# Access Compliance Report

## Public Rights-of-Way

### (Curb Ramps)

Intersection ID: 6128	Main Street: RUMSTONE_LN	Cross Street: STONE_MOUNTAIN_CT	Location: NW
ADA ID: 79C54D165675	Ramp Type: BlendTrans1	Initial Pass/Fail: Fail	Overall Compliance: No
		Severity Score: 10

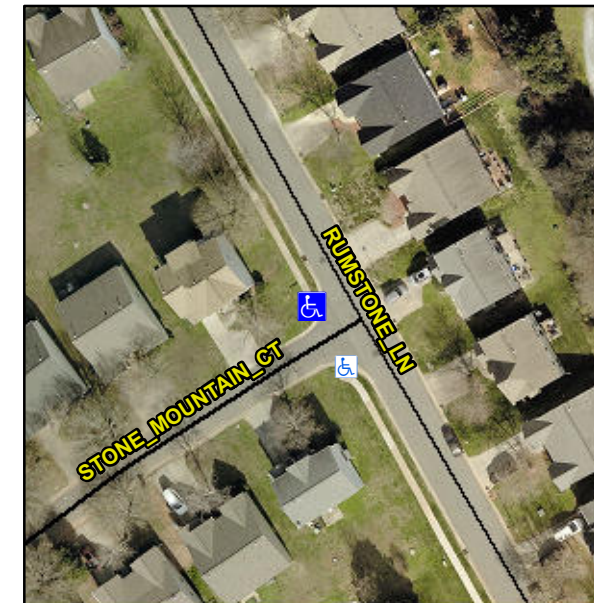
**NO LT SW**

**Not Found, R304.5.1, R304.5.3**

**Remove & Replace Curb Ramp With Two New Directional Ramps or Equivalent.**
